CITY OF MADISON
CITY ENGINEERING DIVISION
DEPARTMENT OF PUBLIC WORKS
PLAN OF PROPOSED IMPROVEMENT

PFLAUM ROAD ASSESSMENT
DISTRICT - 2025

CITY PROJECT NO. 14781
CONTRACT NO. 8747

1. REV#1 - ISSUED 8/3/26
2. REV#2 - SHEETS U6-U8, U11-U13, U17, U18, W6, W8, W14, W16, W17, & W24 UPDATED.

U-11

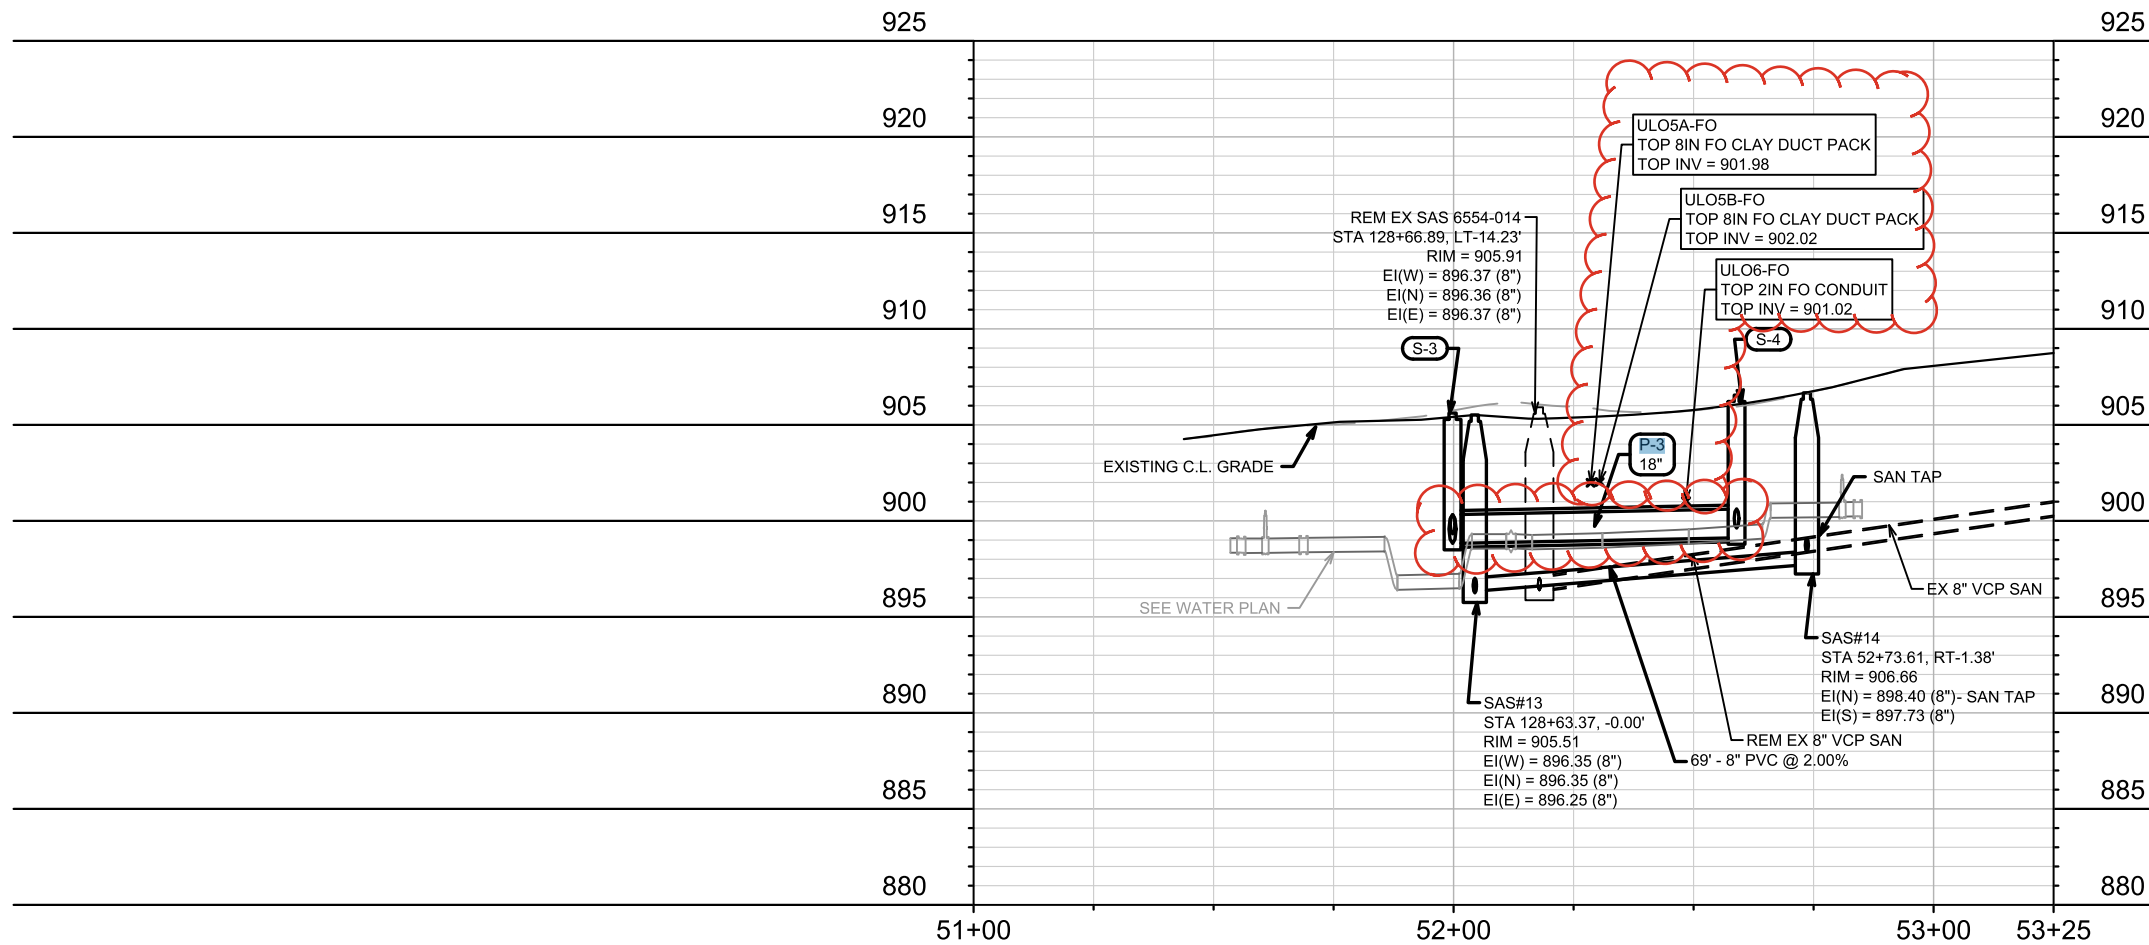
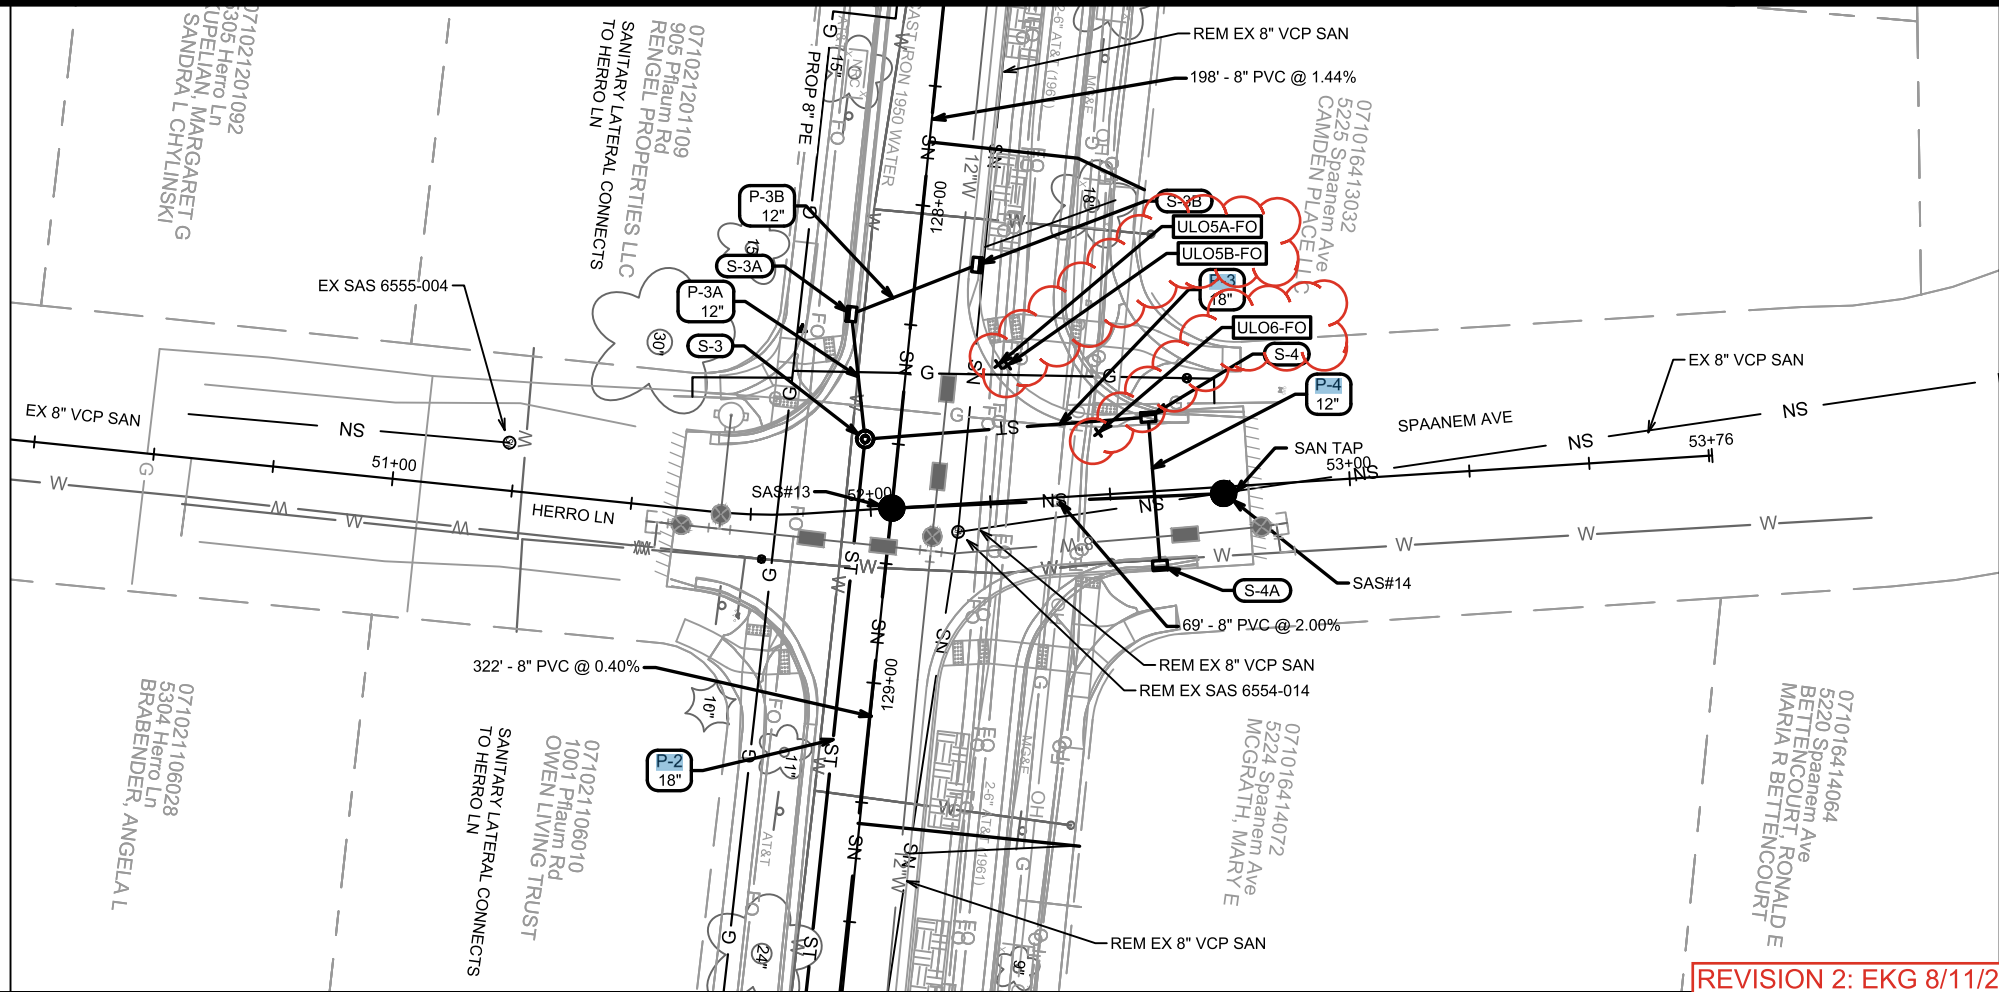
REVISION 2: EKG 8/11/26
Updated ULO locations based on
ULO results. Added ULO5B.
Added ULO results to profile.
Lowered storm sewer inverts to
avoid conflict with FO.

MARK	REVISION	DATE	BY
14781	5/6/2026 8:11 AM		X-8

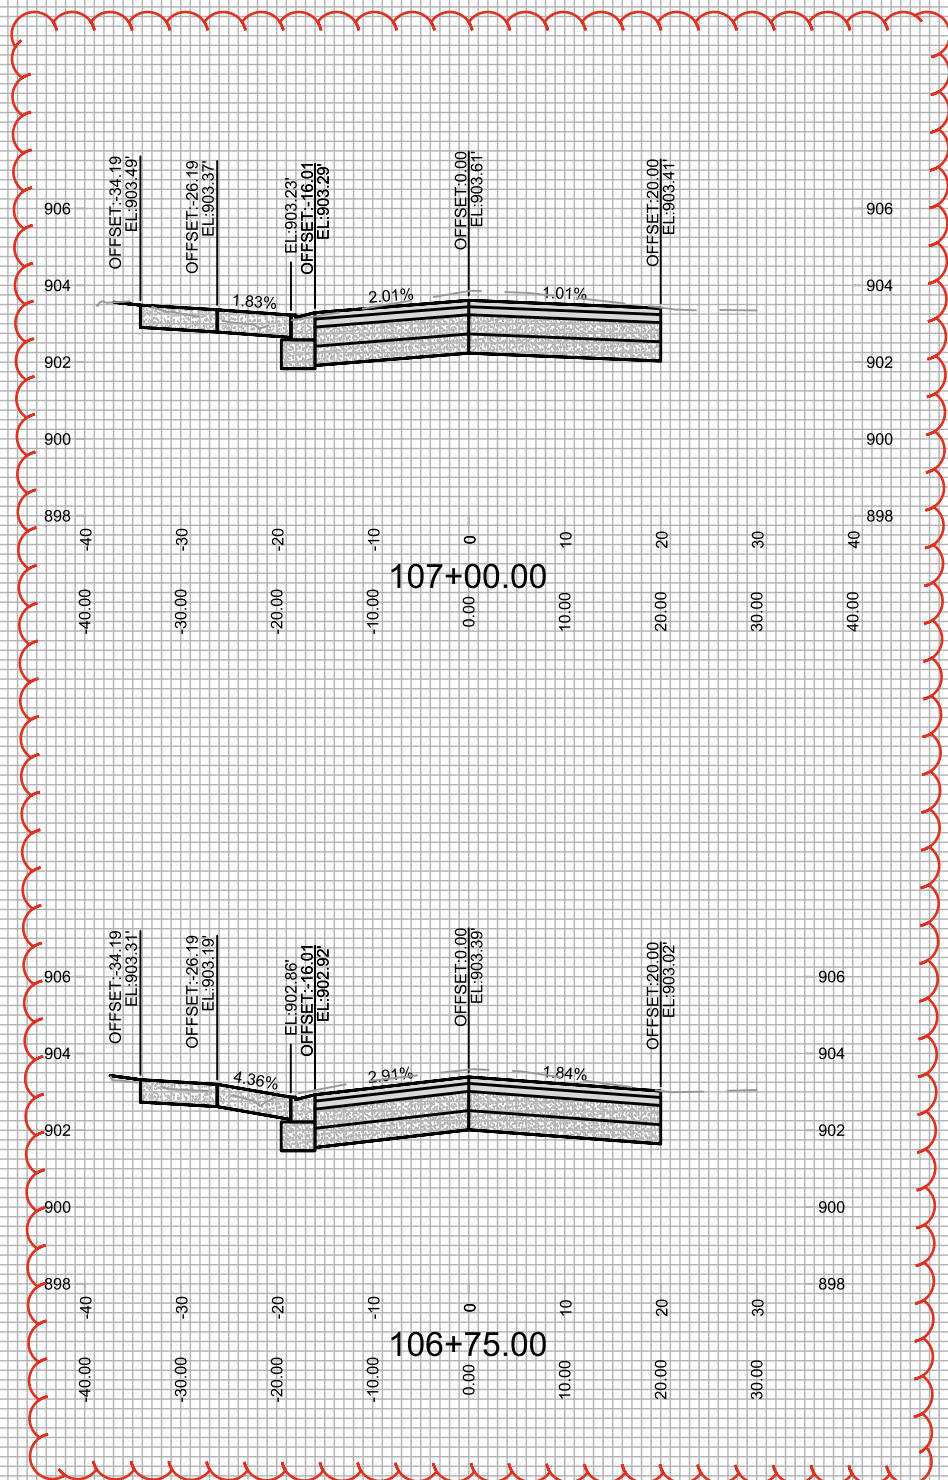
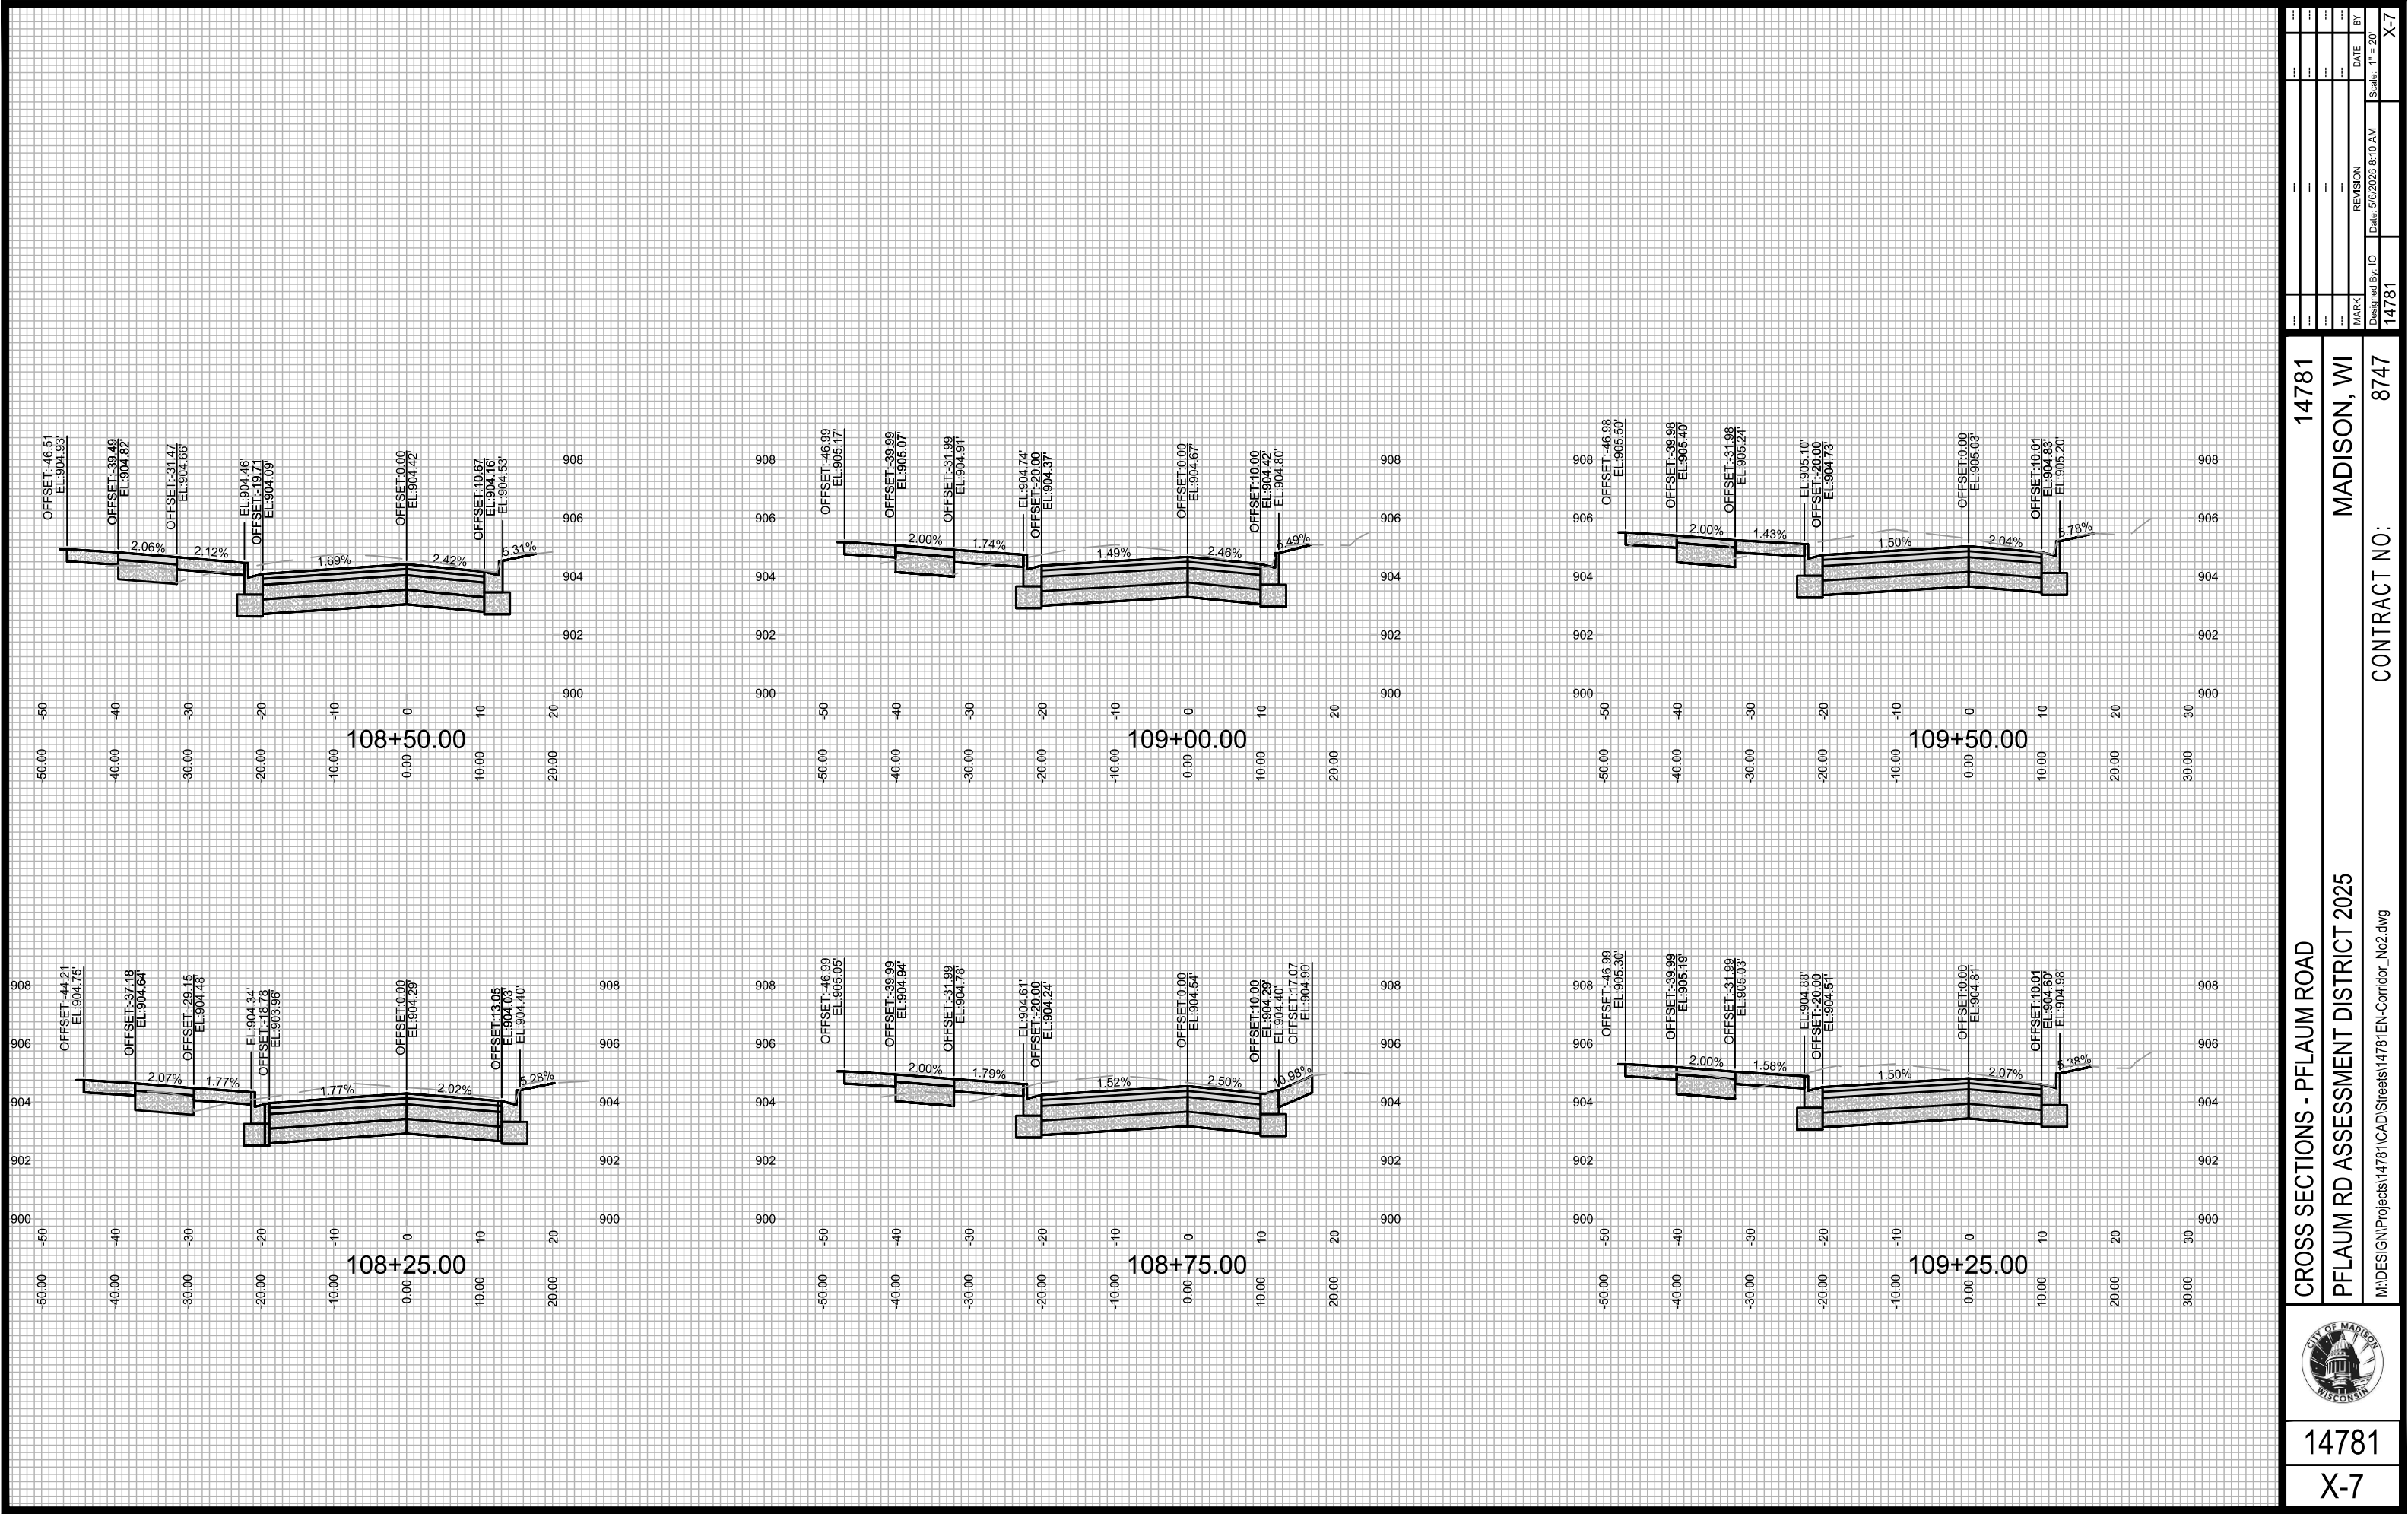
REV#1 - IO - 7/22/26
1. CURB & DRIVEWAY APRON MODIFIED.
